REMARKS / ARGUMENTS

Application No. 10/679,677  
Reply to Office Action of Aug 5, 2004  
Annotated Sheet Showing Changes

FIG. 1 Element 16 added

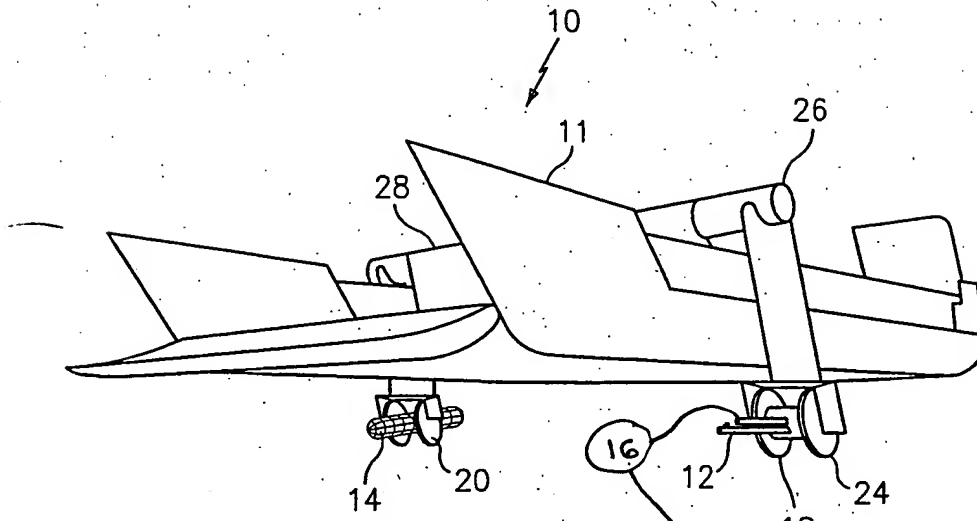
This Office Action is objected to the drawings because numerical indicator 16 (see page 6, line 15) is not illustrated. Corrected drawing sheets are required in reply to the Office action to abandonment of the application. Any amended replacement drawing sheet should include all of the figures appearing on the immediate prior version of the sheet, even if only one figure is being amended. The figure or figure number of an amended drawing should not be labeled as "amended." If a drawing figure is to be canceled, the appropriated figure must be removed from the replacement sheet, and where necessary, the remaining figures must be renumbered and appropriate changes made to the brief description of the several views of the drawings for consistency. Additional replacement sheets may be necessary to show the renumbering of the remaining figures. The replacement sheet(s) should be labeled "Replacement Sheet" in the header (as per 37 CFR 1.84(c)) so as not to obstruct any portion of the drawing figures. If the changes are not accepted by the Examiner, the applicant will be notified and informed of

In the Office Action, the drawings were objected to because numerical indicator "16" was not illustrated. In response, the drawing has been amended to identify the originally-shown barrels of the gun 12 as item no. 16. As such, the objection of the Office Action is resolved.

The attached sheet of drawings includes changes to Fig. 1. This sheet, which includes Fig. 1-2, replaces the original sheet including Fig. 1-2. In Figure 1, previously omitted element 16 has been added.
